WTC DRAWING  
BOOK 19  
AB-1-K-1055

SKILLING, HELLE, CHRISTIANSEN, ROBERTSON

PROJECT	THE WORLD TRADE CENTER	TITLE	DRAWING BOOK 19 - REVISIONS AFTER FABRICATION	DATE	5/18/73
---------	------------------------	-------	---	------	---------

1. The details given in Book 19 define revisions to be made to previously fabricated steel members, or to members under fabrication.
2. The location of such revisions and the detail number are shown in Structural Steel Plans, using the following symbol:

19-A-921

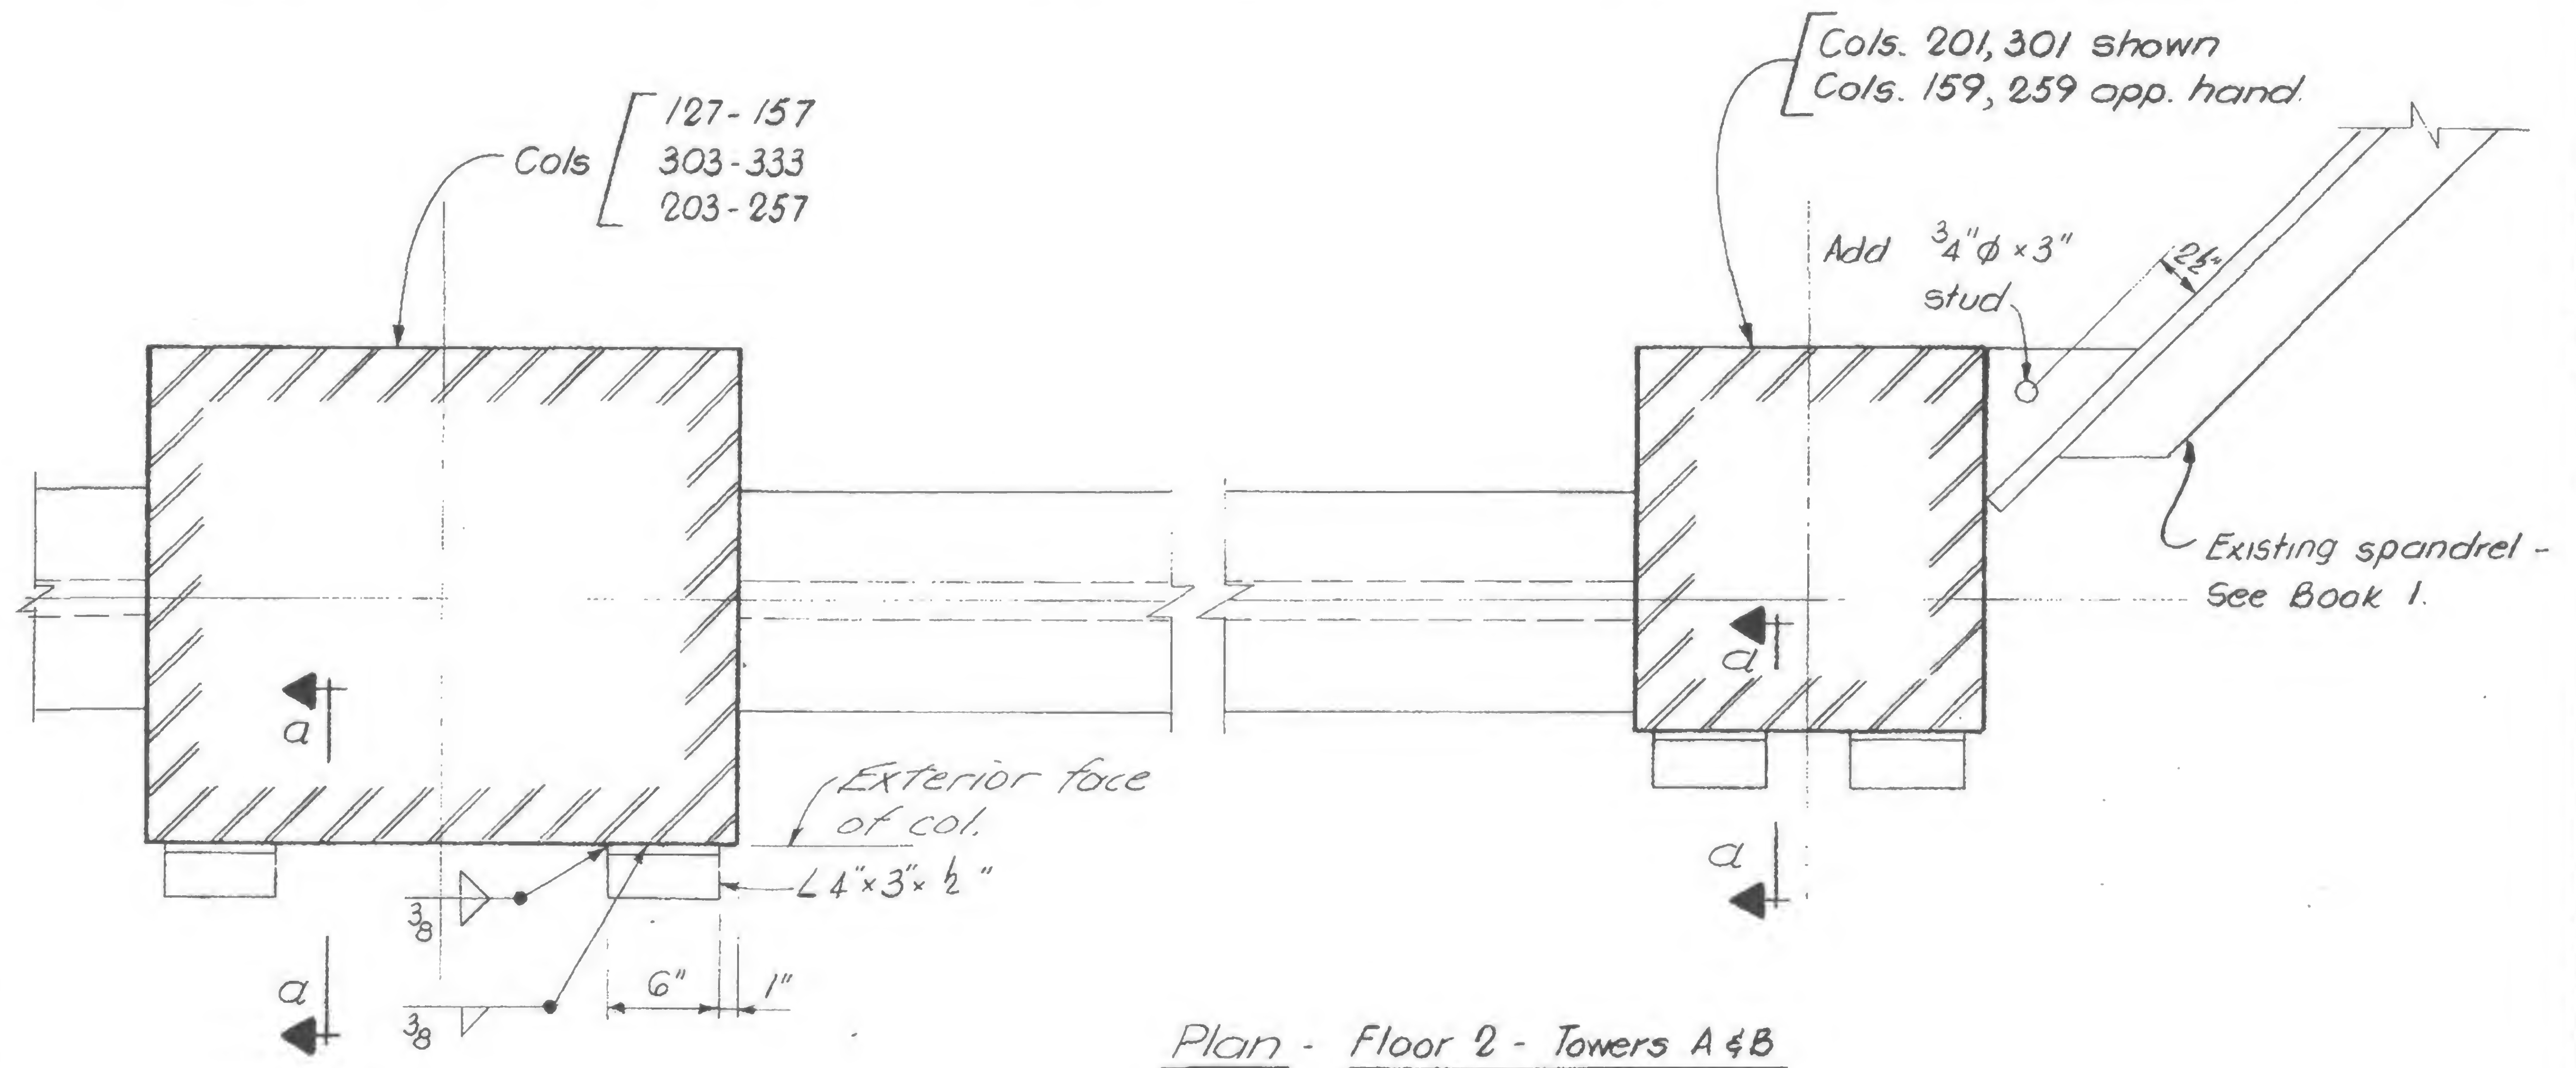
Add two L's per column. Details  
shown are typical for all  
added L's.

19-AB-931

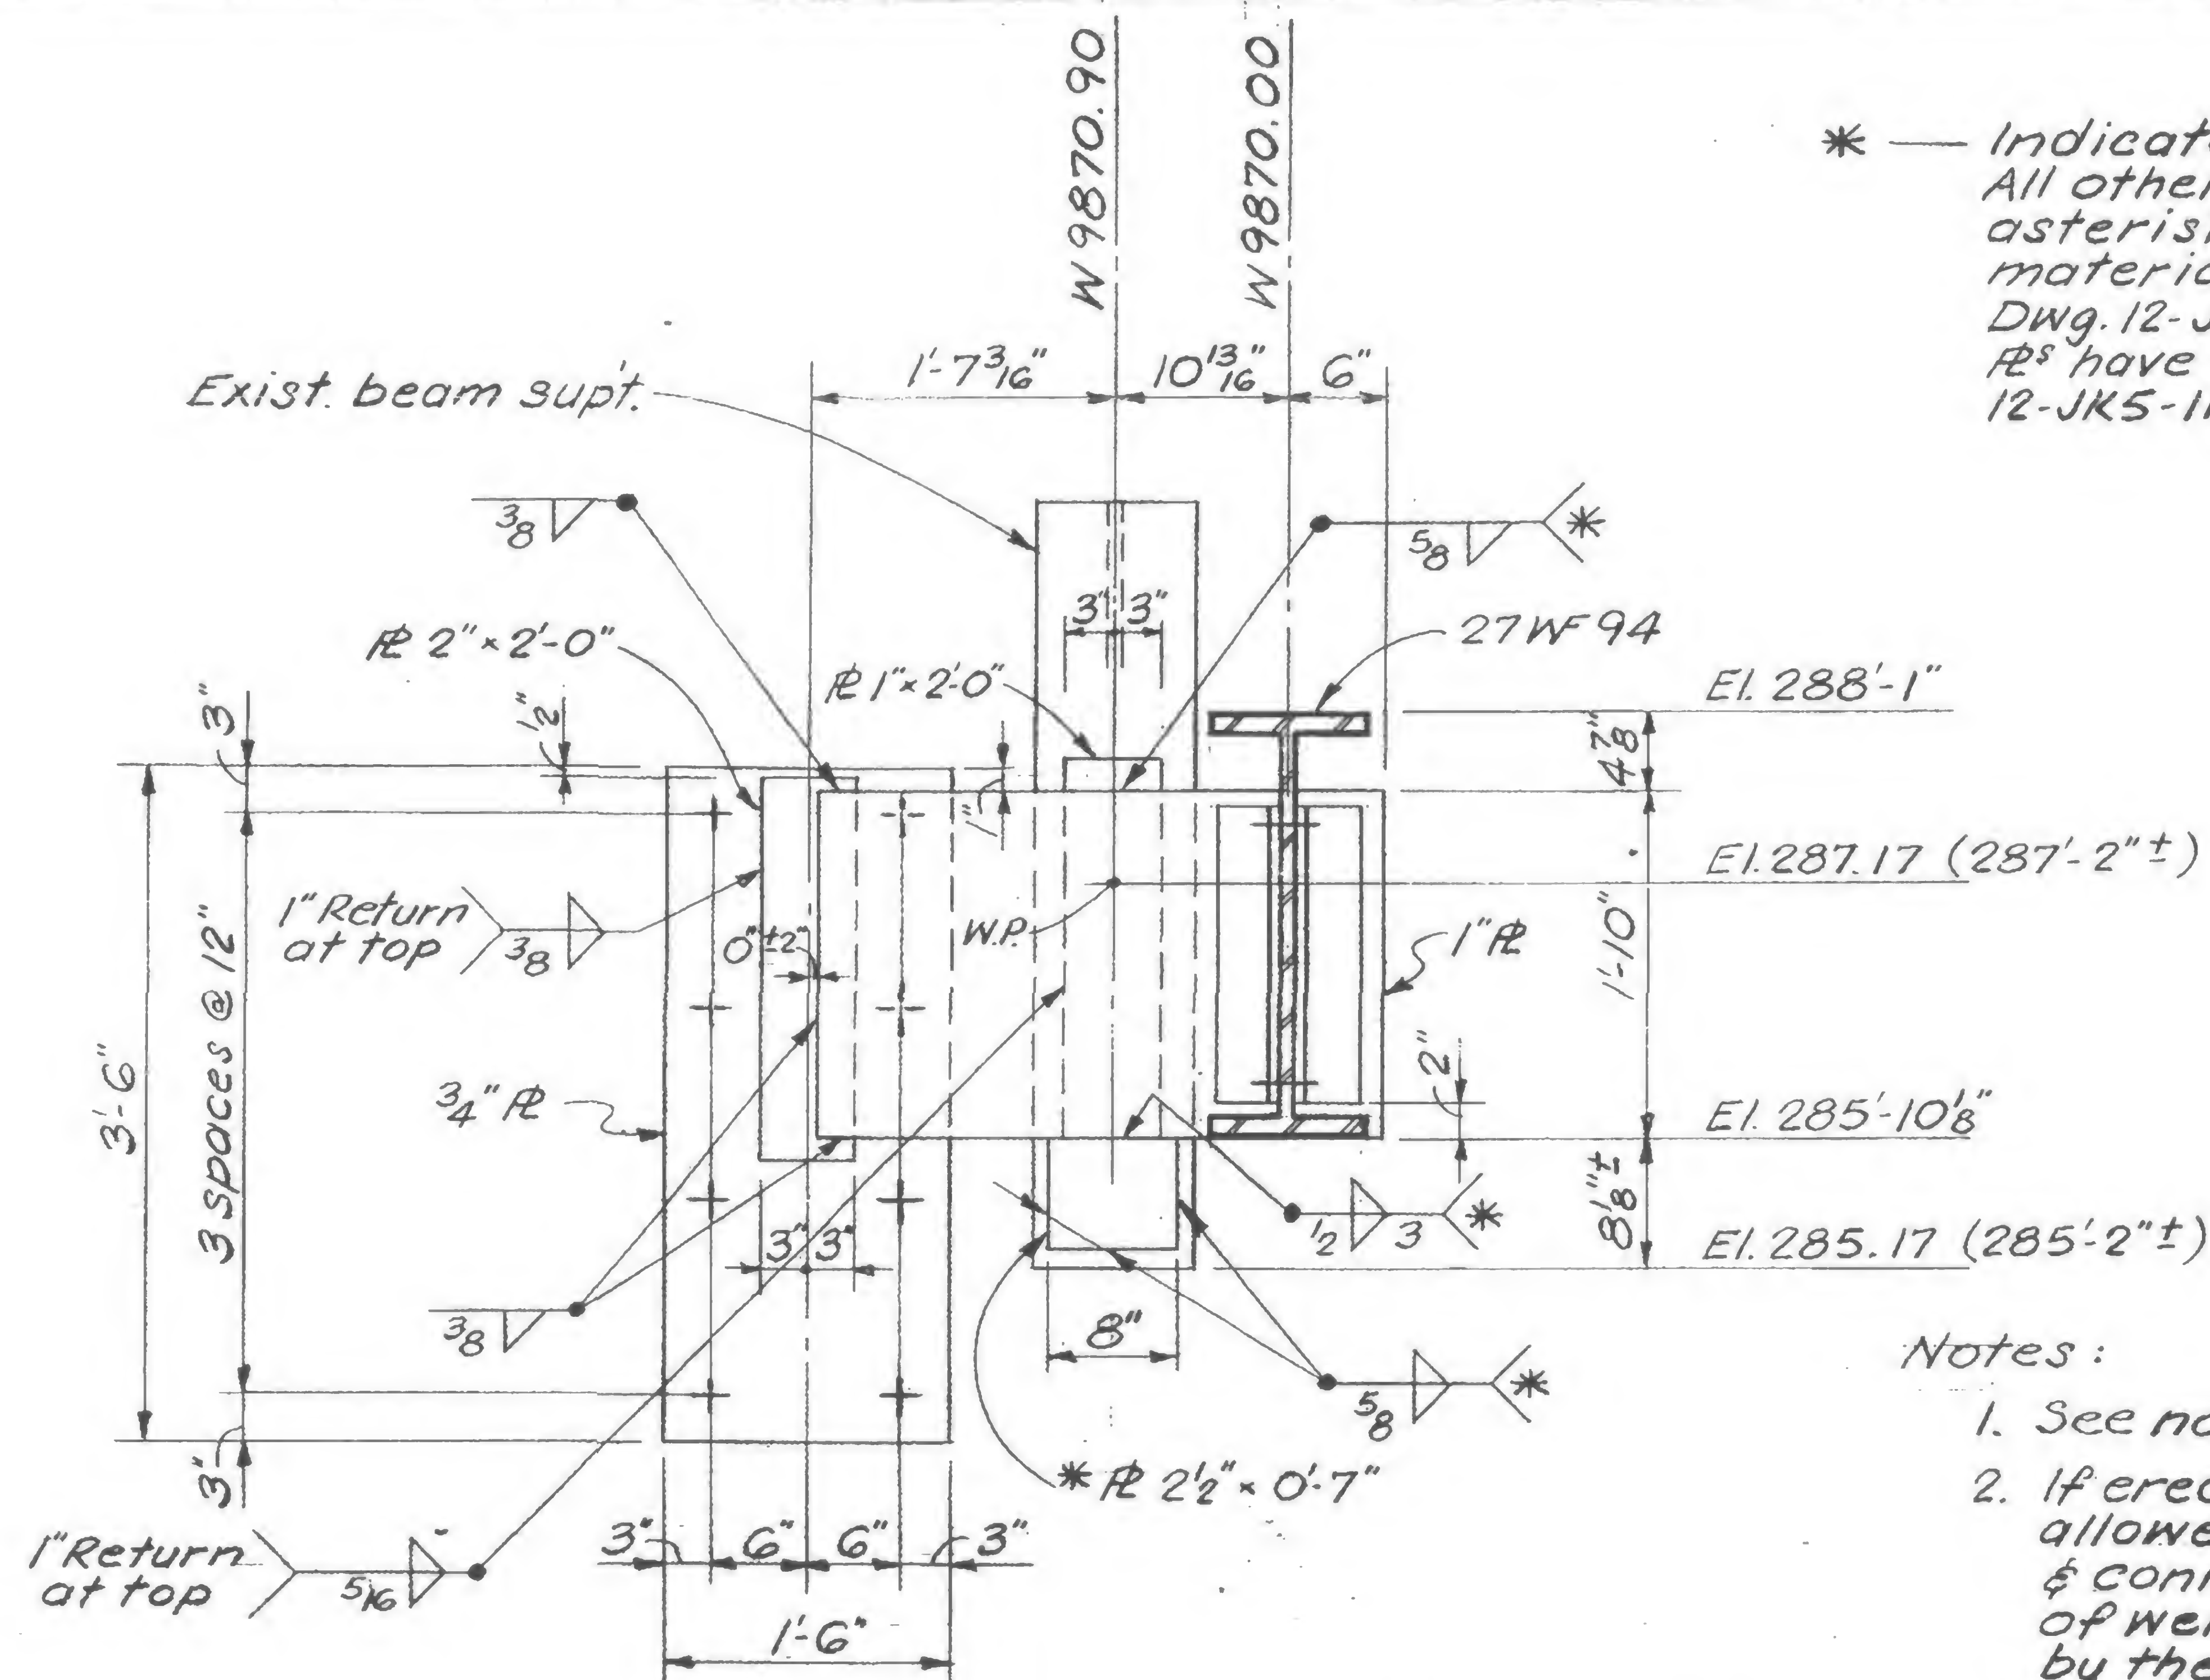
\* — Indicates new R and welds.  
All other items without  
asterisk, are existing  
materials as shown on  
Dwg. 12-JK5-11 (location of  
R's have been revised from  
12-JK5-11)

TOWER A

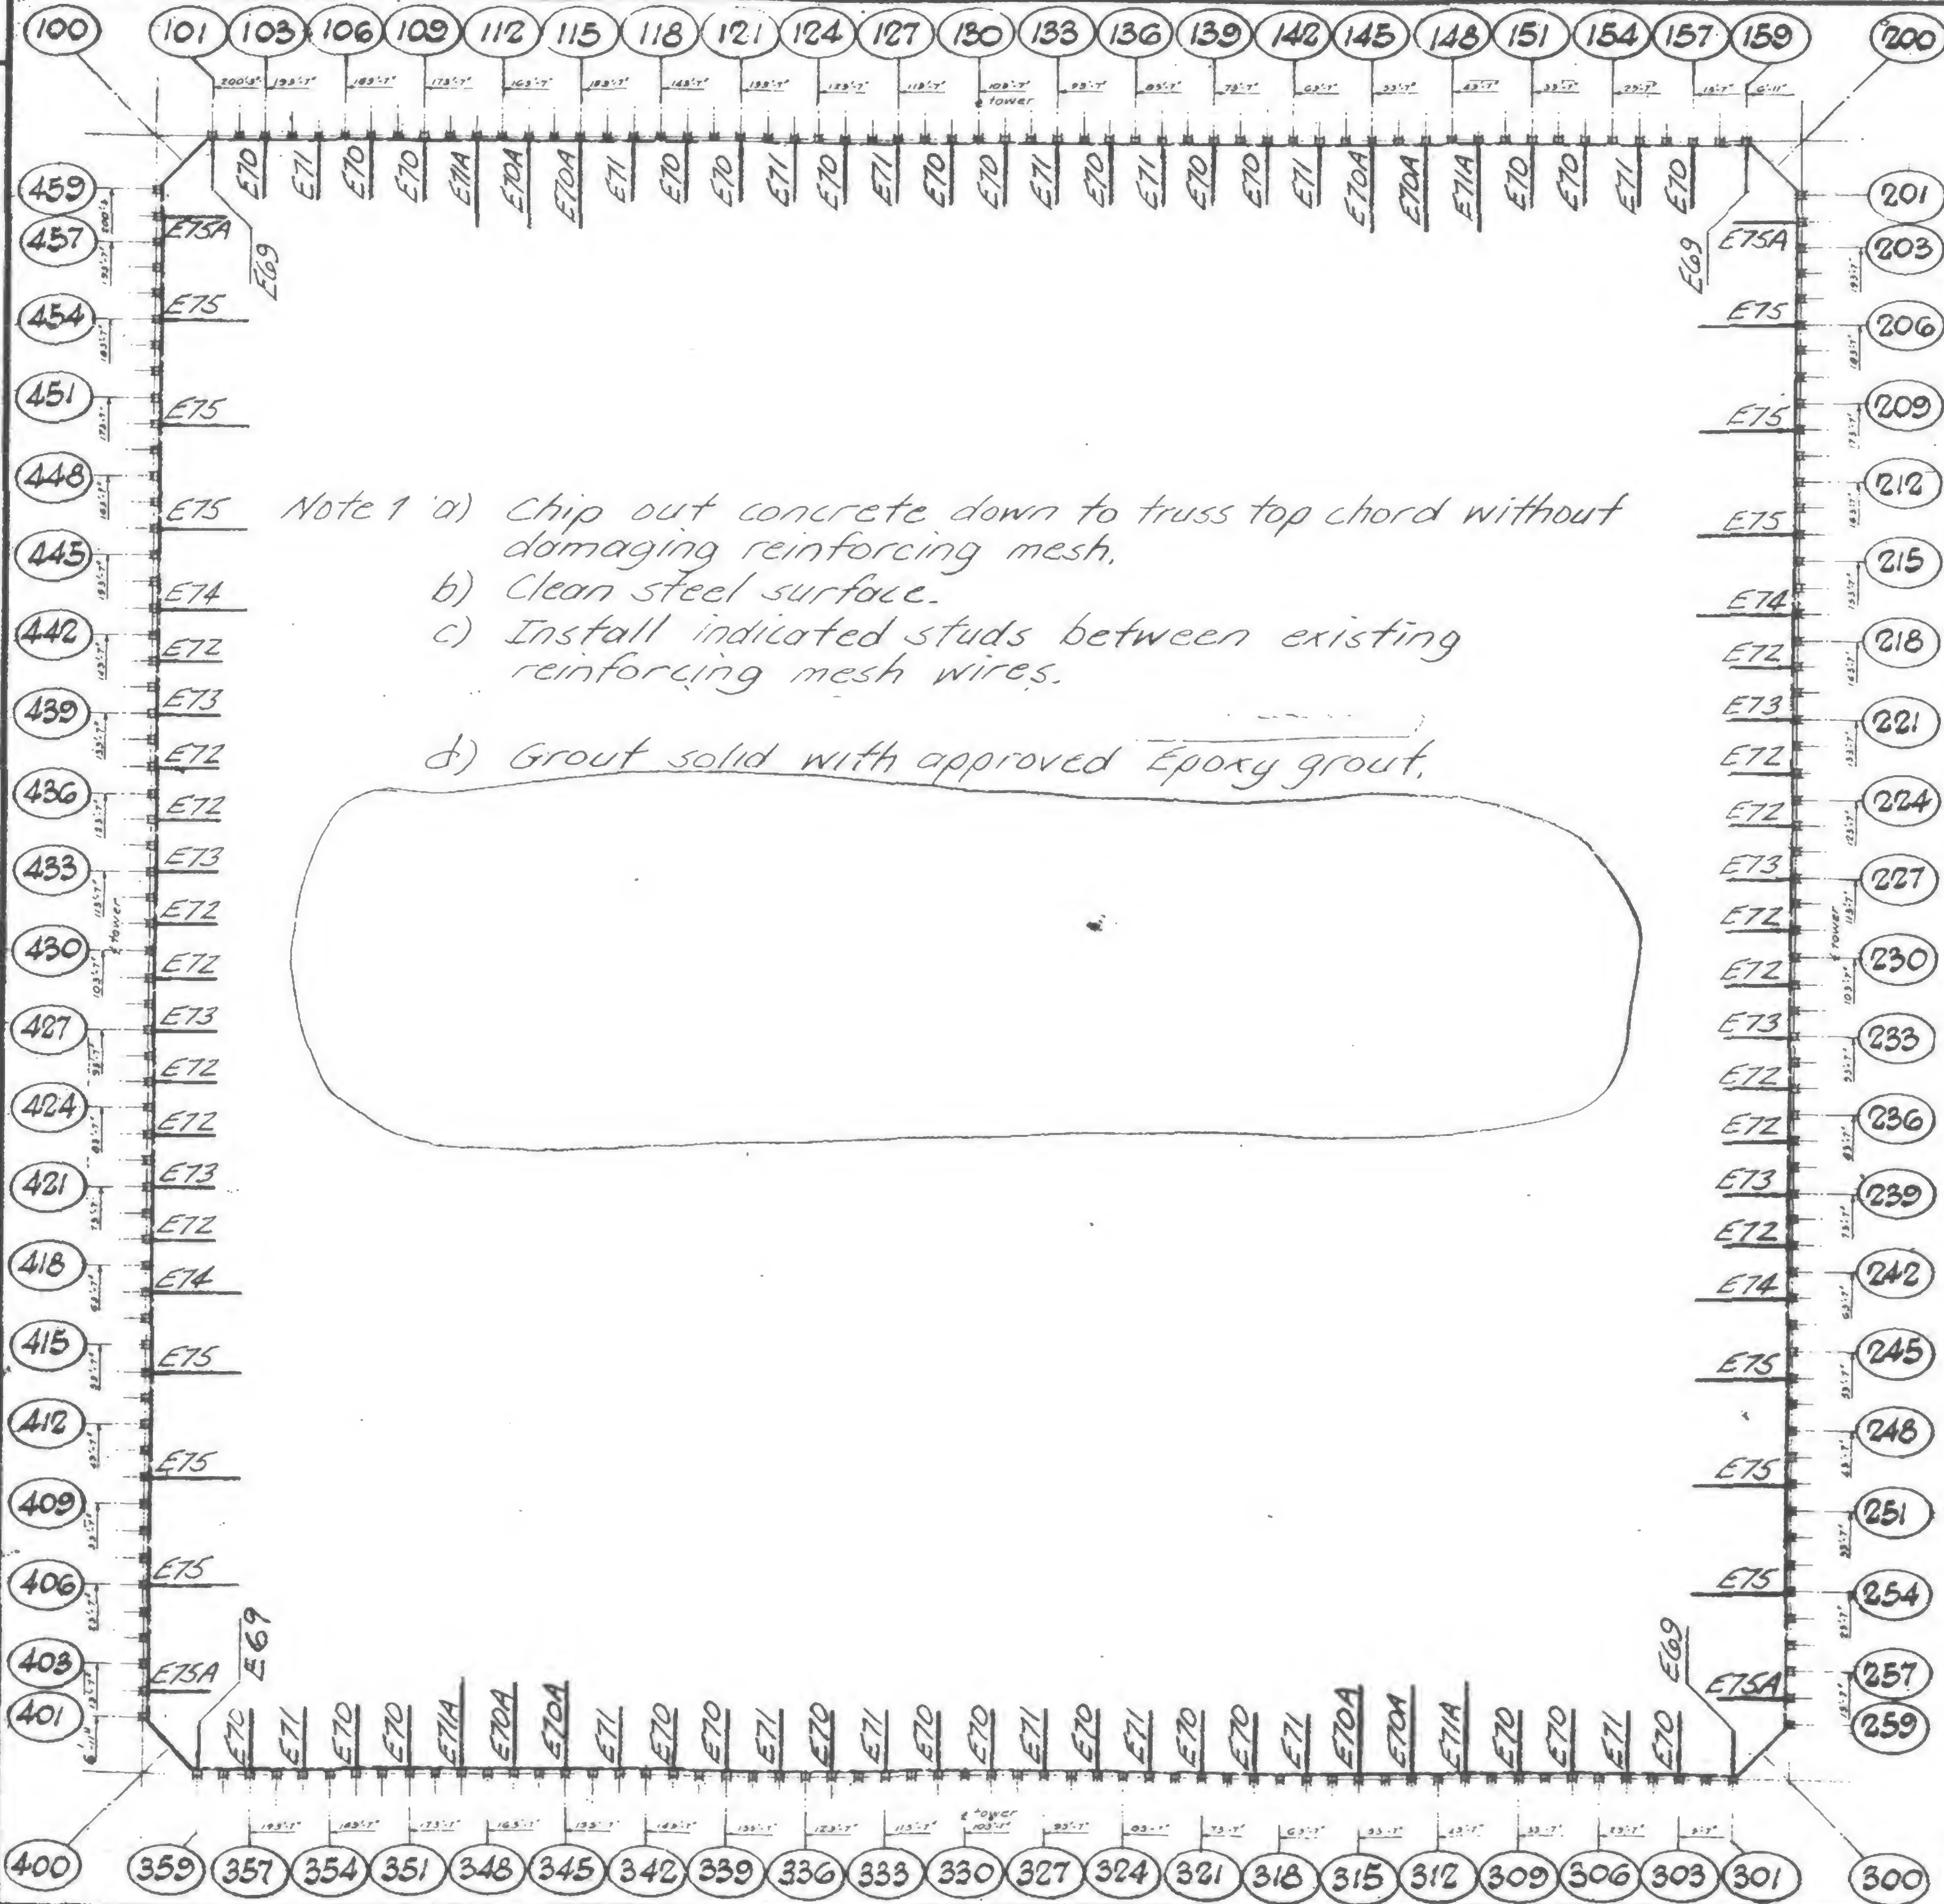
- Note 1
- chip out concrete down to truss top chord without damaging reinforcing mesh.
  - Clean steel surface.
  - Install indicated studs between existing reinforcing mesh wires.
  - Grout solid with approved Epoxy grout.

Det. Sch.	Det. Installed	Corrective Action
E69	E60	None
E70	None	None
E70A	None	E70AR
E71	None	None
E71A	None	E71AR
E72	None	None
E73	None	None
E74	None	E74R
E75	E68	E75R
E75A	E68A	None
